Comment 317

Stephan Schreiner
Rosenberger Hochfrequenztechnik GmbH & Co. KG
January 2025

- Support of Comment 317 regarding Mixing Segment Return Loss

Return Loss TCI and Channel Current proposal

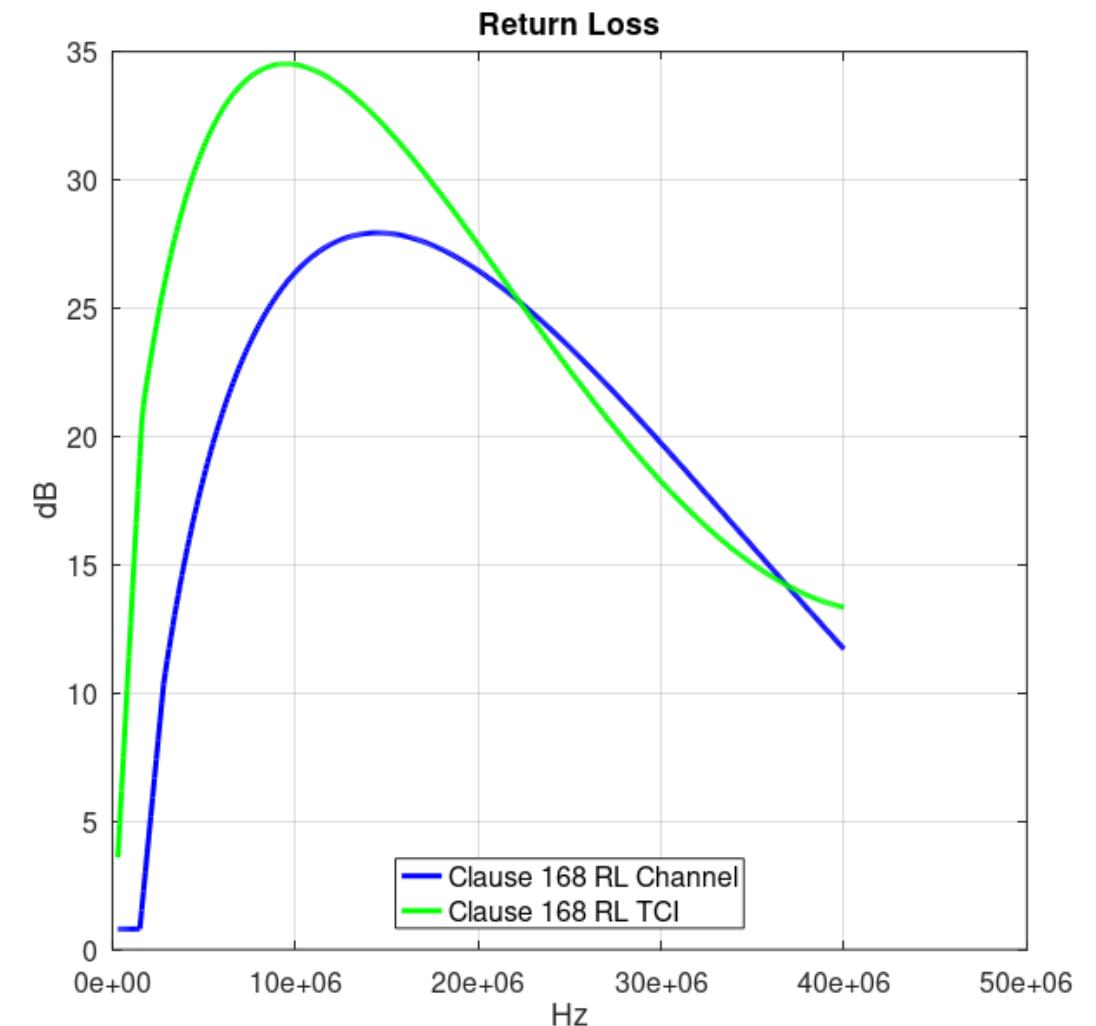
▪ Crossing between TCI return loss and channel return loss indicates an issue at the construction of the channel return loss

S_{DD11} and S_{DD22} of Channels

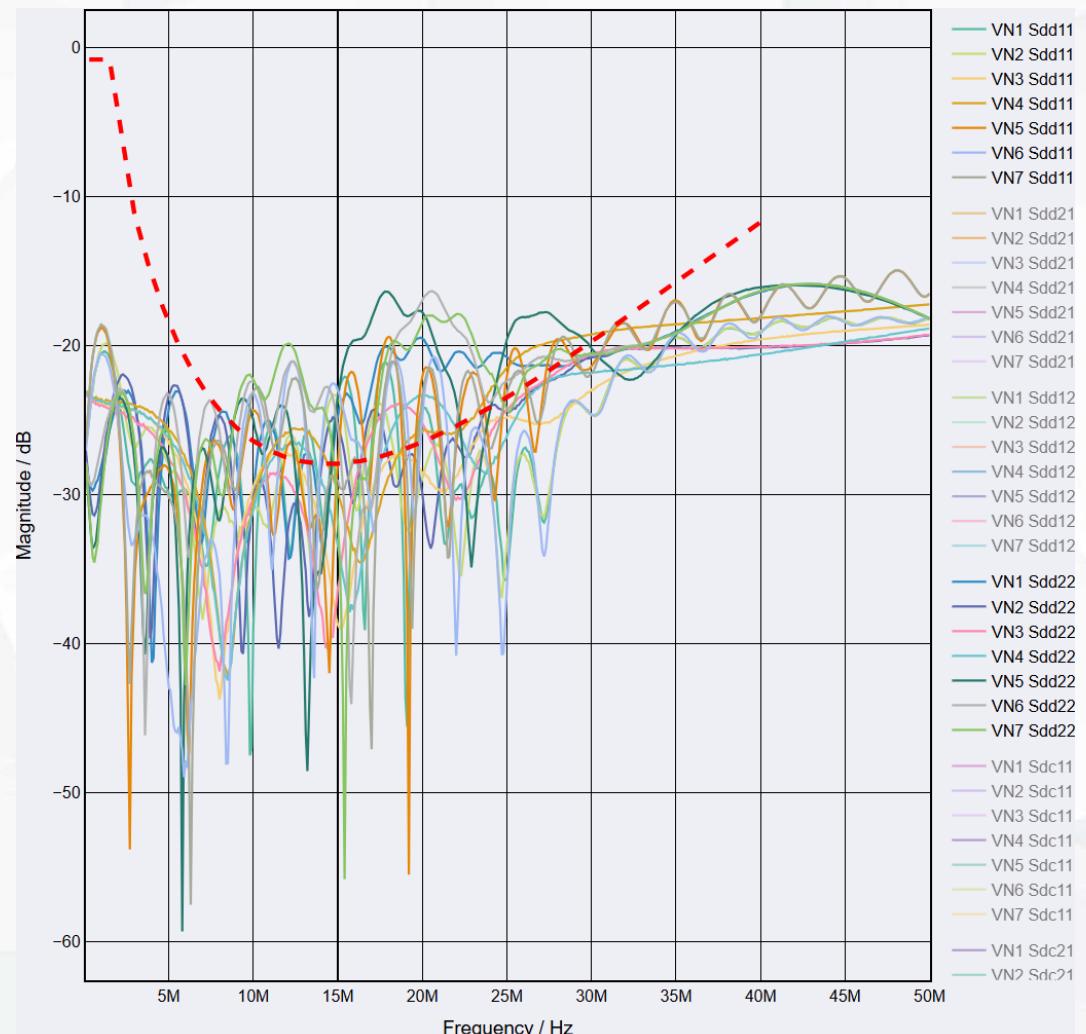
- Channel return loss is significant above limit

S_{DD11} and S_{DD22} of Channels

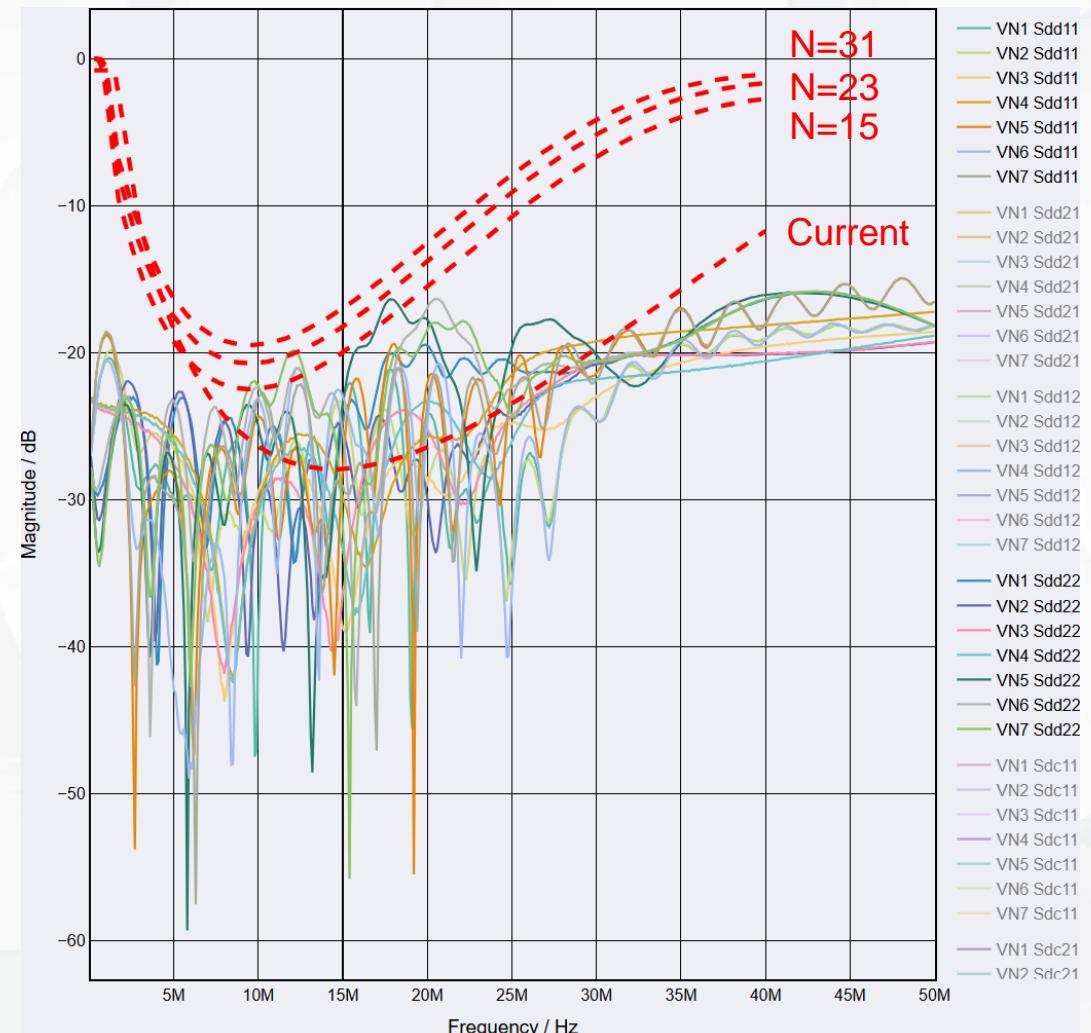
- Each TCIs RL contributes to the channel RL
- Under the Assumption: The reflection of each TCI adds up as power during measurement, reflected power is missing at input of next TCI
(This assumption is typically not used for S-Parameters)

- $N = 15$: All nodes power sum (optimistic)
- $N = 23$: Additional small margin
- $N = 31$: Additional increased margin

S_{DD11} and S_{DD22} of Channels

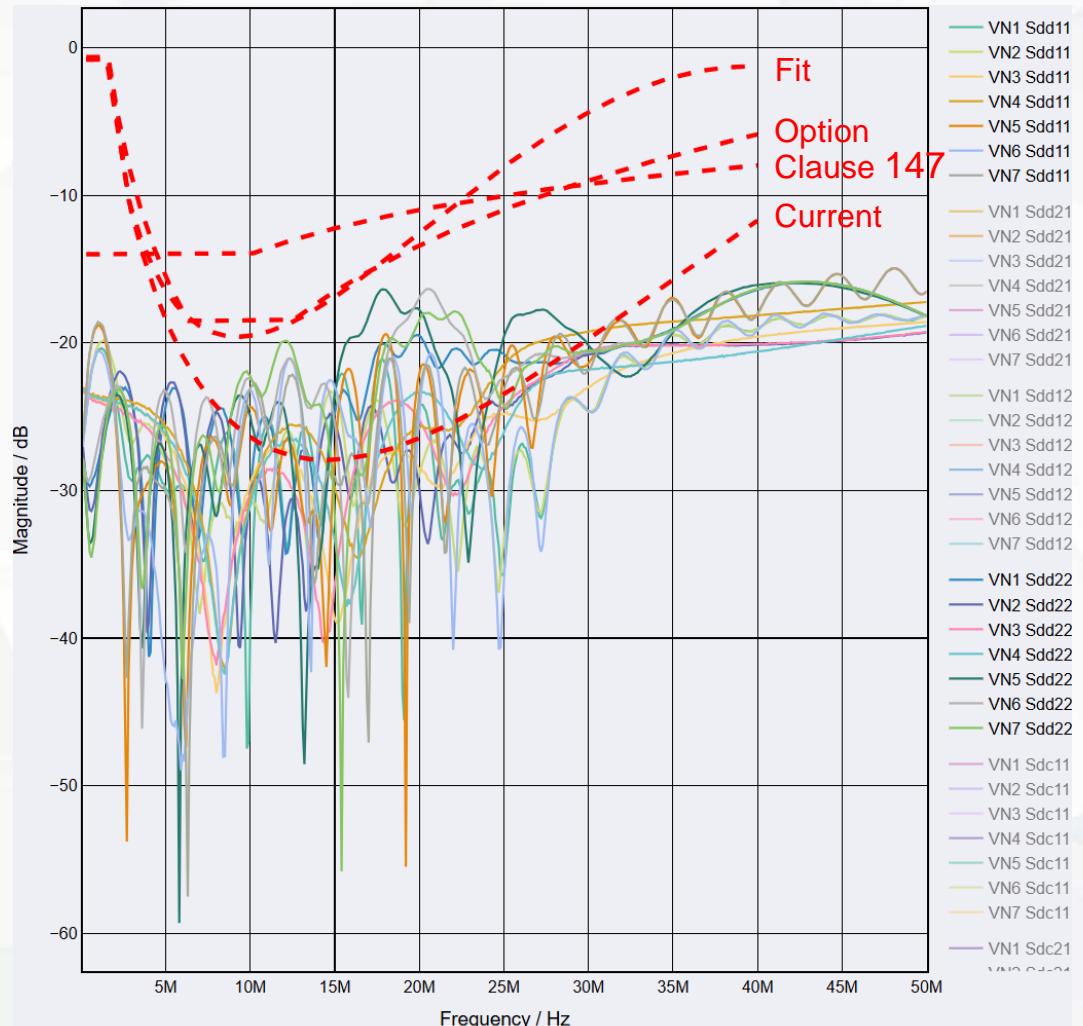
Apply Curve Fitting

- **Equation for Fit:**

- **Fit:**

- **Option:**

$$RL(f) \geq \begin{cases} 0.8 & 0.3 \leq f < 1.6 \\ 7.91f - 11.85 & 1.6 \leq f < 2.8 \\ -43.3 - 20 \log_{10}(f) - \frac{0.97}{f} + 51.9\sqrt{f} - 8.73f + 0.061f^2 & 2.8 \leq f \leq 40 \end{cases} \text{ dB}$$

$$RL(f) \geq \begin{cases} 0.65 & 0.3 \leq f < 1.6 \\ 0.65 + 30 \log_{10} \left(\frac{f}{1.6} \right) & 1.6 \leq f < 6.4 \\ 18.5 & 6.4 \leq f \leq 12.5 \\ 18.5 - 25 \log_{10} \left(\frac{f}{12.5} \right) & 12.5 \leq f \leq 40 \end{cases} \text{ dB}$$
